**PLANNING REPORT IN ACCORDANCE WITH
SECTION 179 3(a) OF THE PLANNING AND DEVELOPMENT
ACT 2000 (as amended).**

Re: Permission for Croom Distributor Road - provision for a scheme to advance the unbuilt section of the distributor road to complete the link to High Street R516 at its southern extent and a distributor road between Crecora Road and Limerick Road to the north. In addition, a new road will be constructed to the north of the proposed distributor road crossing the Laskiltagh River to accommodate access to a proposed post-primary school which will be located north of the river. The proposed road will be a single carriageway road (6.0m carriageway road) with a shared cycleway/footway (1.5m wide cycleway and 1.5m footpath). A 1.0m buffer from the carriageway is also included on both sides of the carriageway with associated earthworks and verges. New junctions will be formed with the existing roads including a roundabout on the Crecora Road. There will be associated road signage/markings, drainage and utility services constructed. In addition, there will be an attenuation pond to facilitate sustainable drainage systems

At Skagh, Croom, Co. Limerick.

Planning Reference No. 17-

Figure 1: CFRAM Study Flood Extent (dashed line = indicative 1%AEP flood extent Croom 1d/2d model)

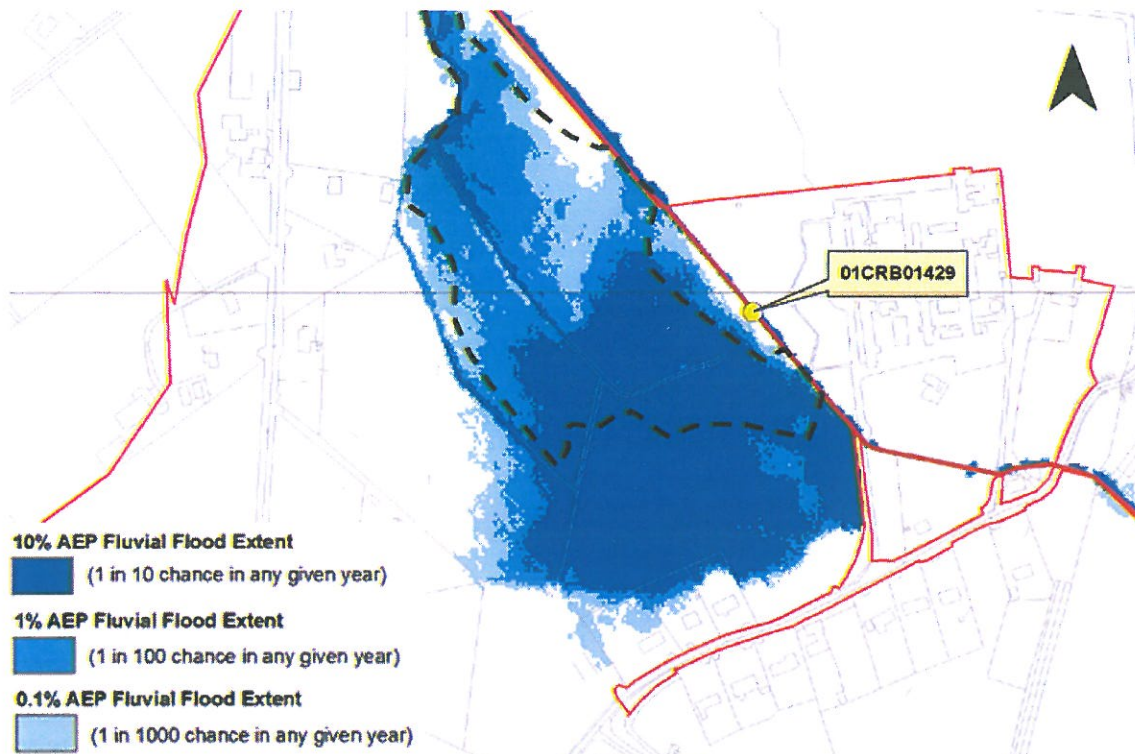
"The application contains Flood risk modelling assessing the effect of the proposed development. Due to the limitations of the modelling and certain assumptions as detailed within the report, particularly with respect to the lack of detailed hydrogeological analysis, it is the opinion of this office that the flood risk to property in the vicinity of the proposed development has not been adequately assessed.

The flood model was carried out on the basis of using the information contained within Shannon CFRAM report as this was published by the OPW at the time of undertaking the flood model and is considered current information. This report uses flows based on the FSU methods of calculation (OPW, 2005). The flood model report based on this information was submitted with the planning application. This report (ref: 356664SA-01 Rev C) details the methods used when undertaking the flood model. It used flows based on the flows contained within the OPW CFRAM report. The design team undertook a quick exercise to review these flows and found them to be suitable. The flood model went a step further in that it used a 1D/2D model rather than just a 1D model. The subsequent flood extent is shown as the dashed line in Figure 1 below.

Based on the information in this report and the flood model undertaken, it is not considered that the proposed road development has increased the flood risk in the area. Furthermore, the house as outlined in the previous correspondence is not shown to be at risk with the scheme in place.

Drawing Title: **Alternative Detail at Moloney Property**

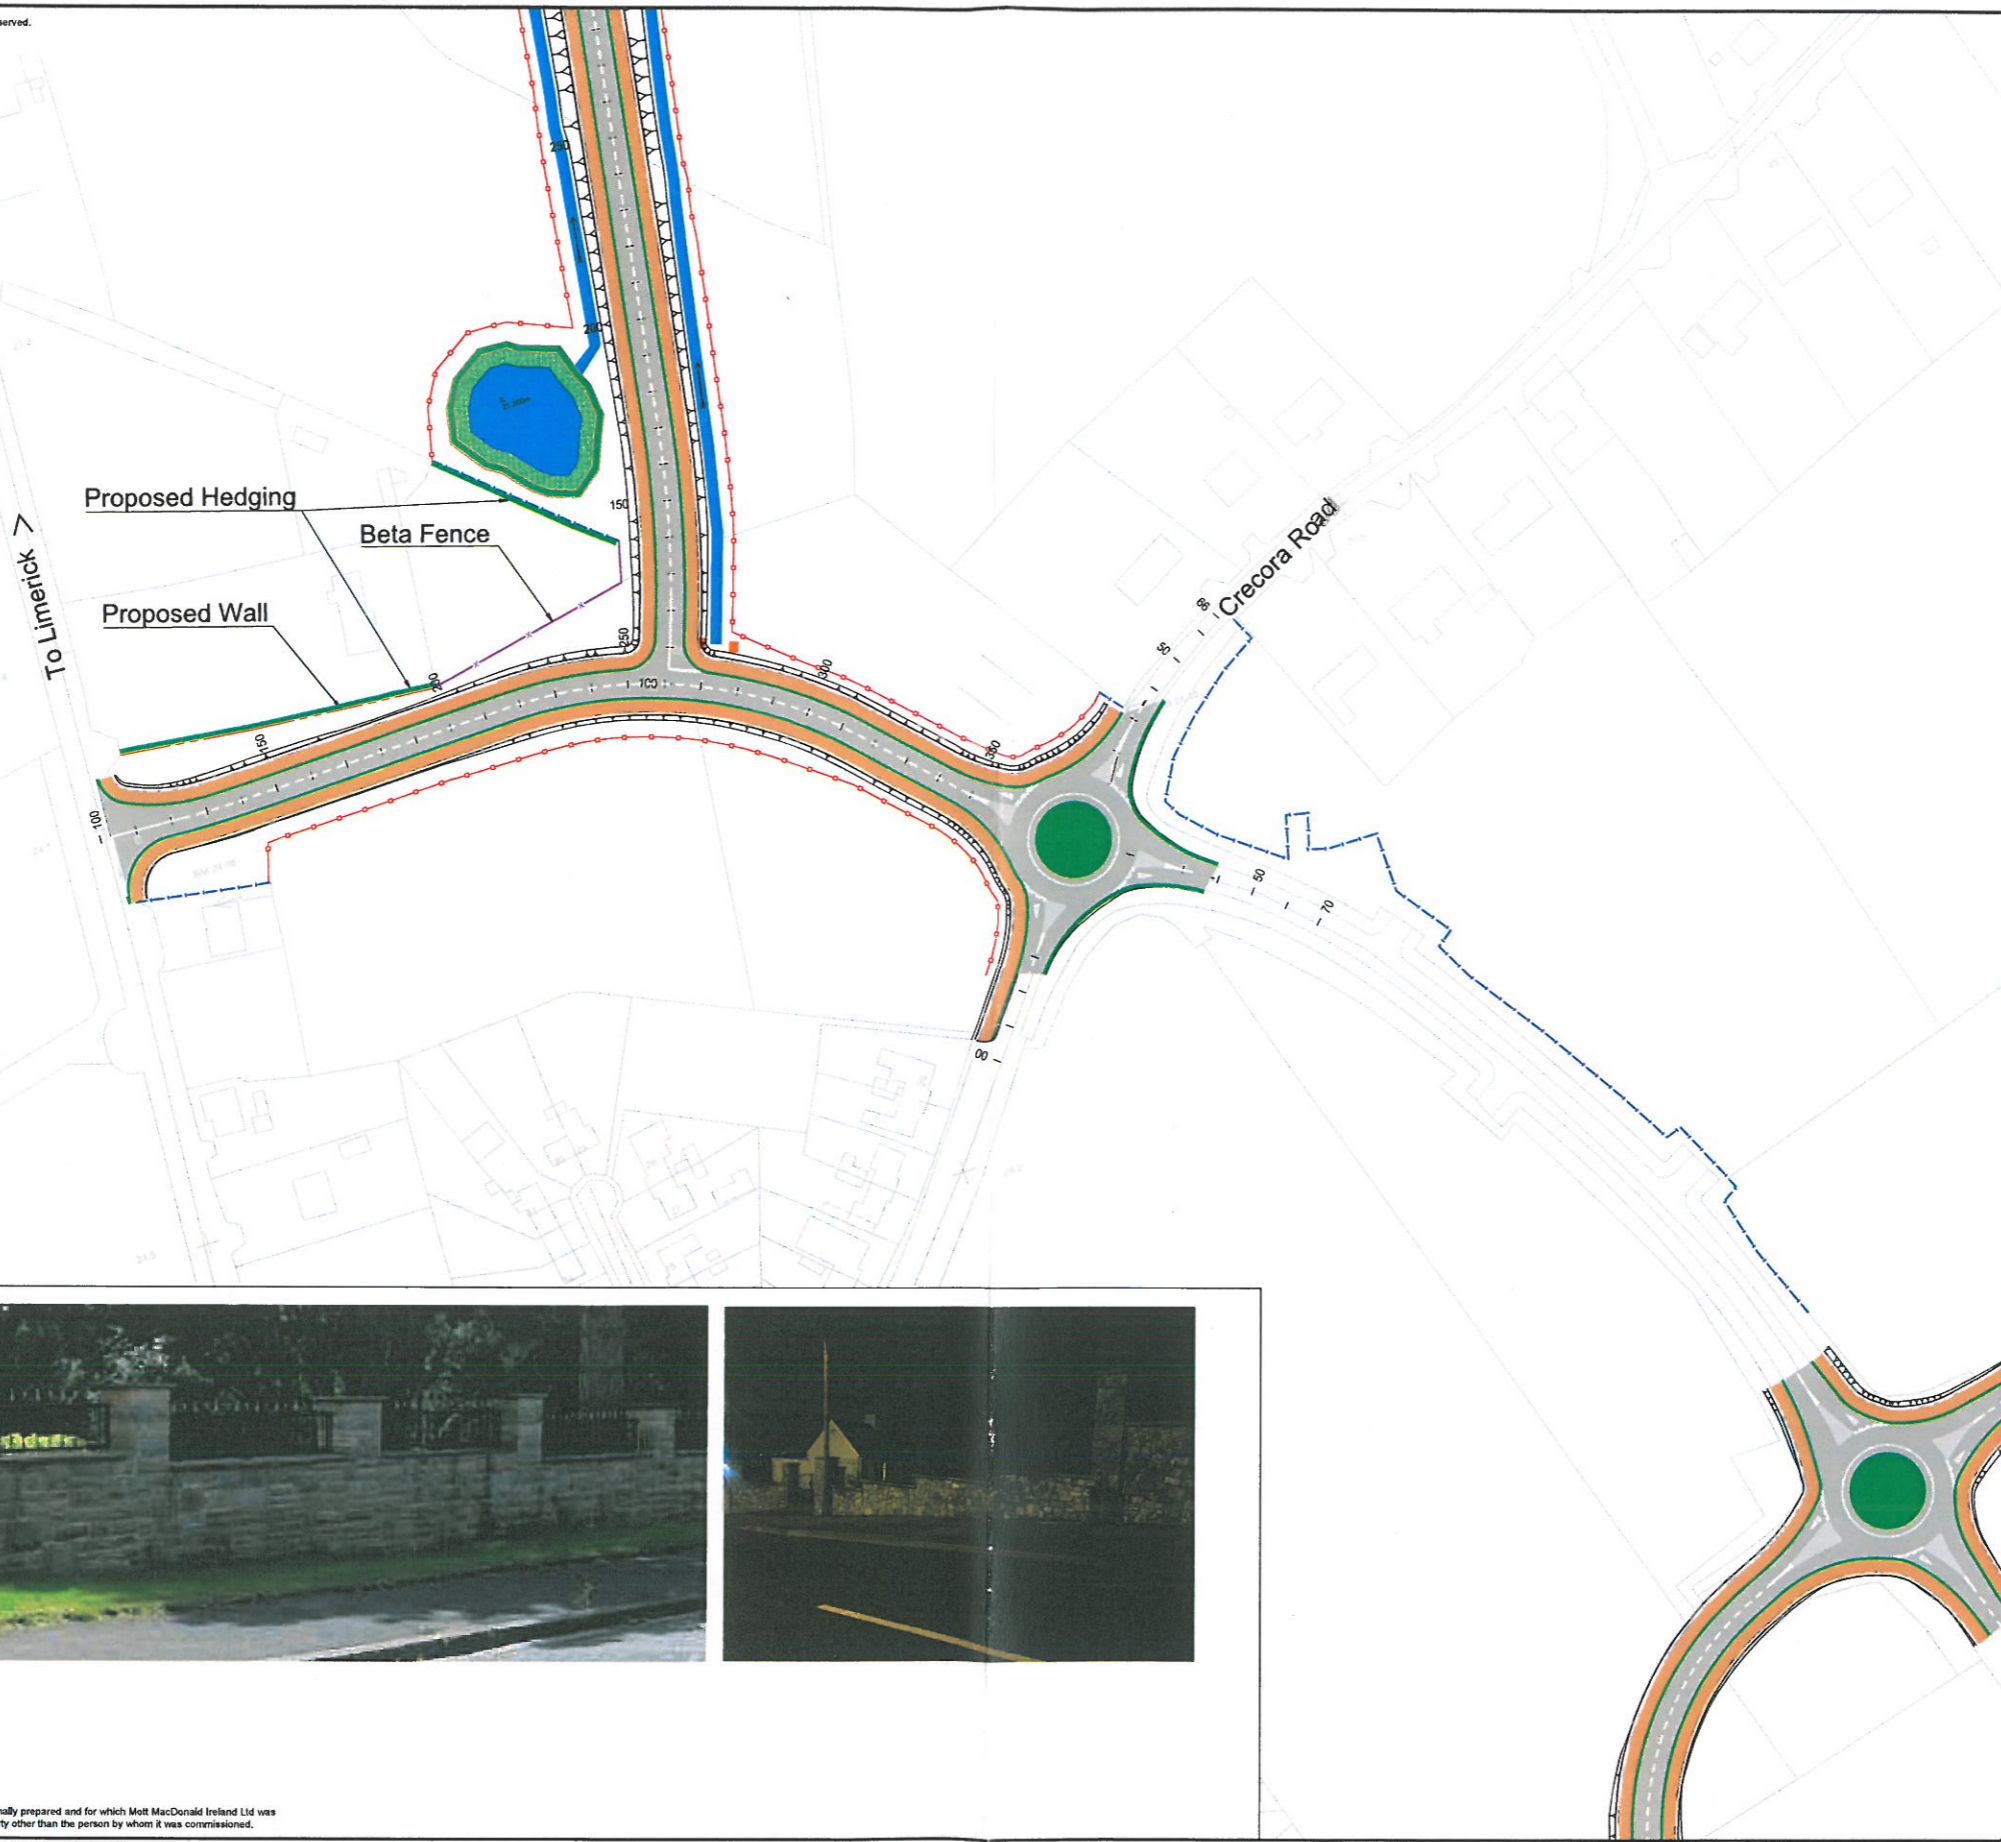
The following outline the main points of the submission: The proposed road development will bound the full extent of Mrs Moloney's property. The property is not currently accessible by the public. The construction of the road will alter the boundary from an agricultural one to a public road boundary. If the proposed road development is constructed the existing boundary won't be 'fit for purpose' on health and safety, security and privacy grounds. She requests the construction of a 1.8m high stone-faced wall or a 1.8m high concrete wall with planting adjacent with mature tree planting along the part of the boundary that does not interact with the proposed road development.

1. The Costello's are losing the biggest proportion of land by comparison with other landowners in the area.
2. The existing (foul) sewer is already going through Costello's land and they would like to see this relocated as part of the proposed road development.
3. Less than 50% of their landholding will be available for residential development as per its zoning. They requested a design change by realigning the road to the west by 40m.
4. They have requested three connections onto the proposed road development to enable their proposed future development.
5. They are in support of the proposed road development in principle.

Discussions have been held with Mrs Moloney and it is considered that a wall can be constructed along the boundary with planting to retain the privacy and security of the property. The boundary shall not exceed 1.8m high.

3. Consultation with an adjacent landowner has been undertaken with the adjacent landowner and it is possible to realign the road at the location requested by 15m. The resulting scheme layout is as per drawing 367793-SK-0000-0002-P01.

2. The access road to the proposed school shall be realigned 15metres to the west at the junction with the section of proposed road development between the old N20 and the Crecora road as per drawing no: 367793-SK-0000-0002-P01.
Reason: In the interest of proper planning and sustainable development of the area.

5. The boundary wall between the proposed road development and the residence immediately north at the Old N20 junction shall be of solid construction (complying with TII document CC-SCD 02401 or CC-SCD-02405 or similar approved).
Reason: To maintain privacy for the resident at this location.
